CITY OF ALBUQUERQUE

**RE: 1516 Gerald Ave. SE
Grading and Drainage Plan
Engineer's Stamp Date: 02/07/22
Hydrology File: M15D051**

Based upon the information provided in your submittal received 02/07/2022, the Grading and Drainage Plan is approved for Building Permit and Grading Permit. Since this site currently has an existing structure, a pad certification is not needed for this project. Please attach a copy of this approved plan in the construction sets for Building Permit processing along with a copy of this letter.

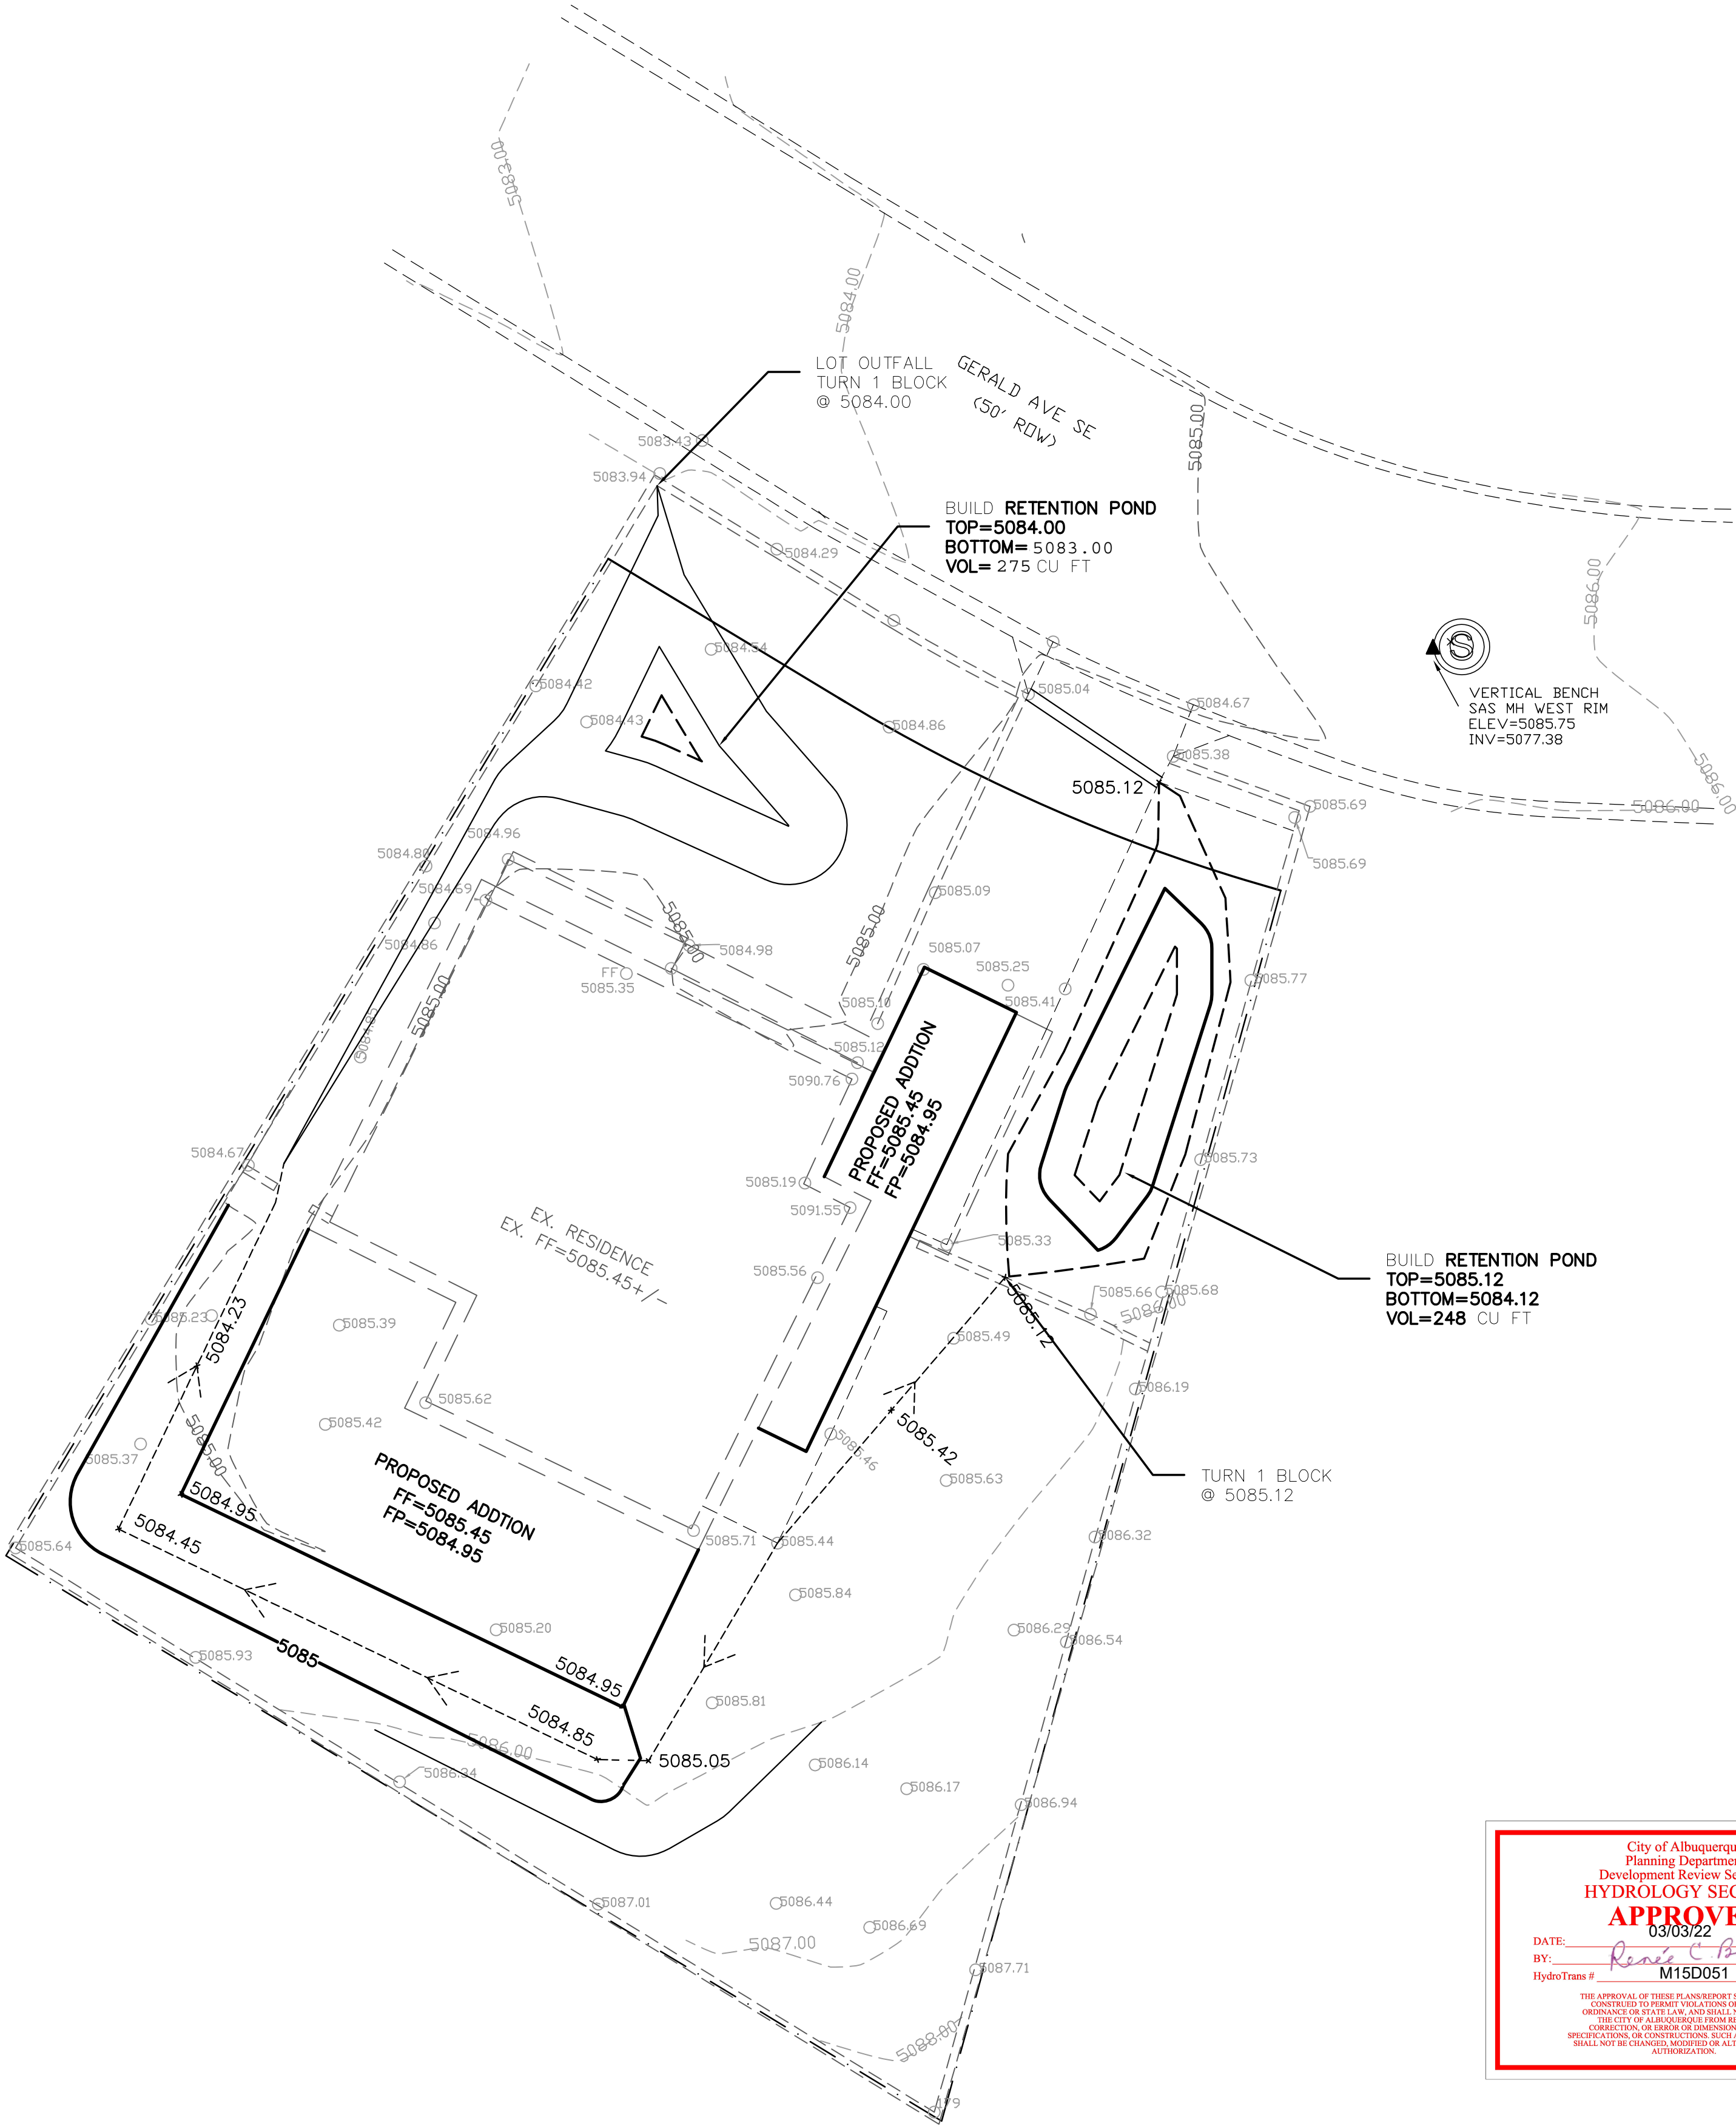
1. Engineer's Certification, per the DPM Part 6-14 (F): Engineer's Certification Checklist For Non-Subdivision is required.
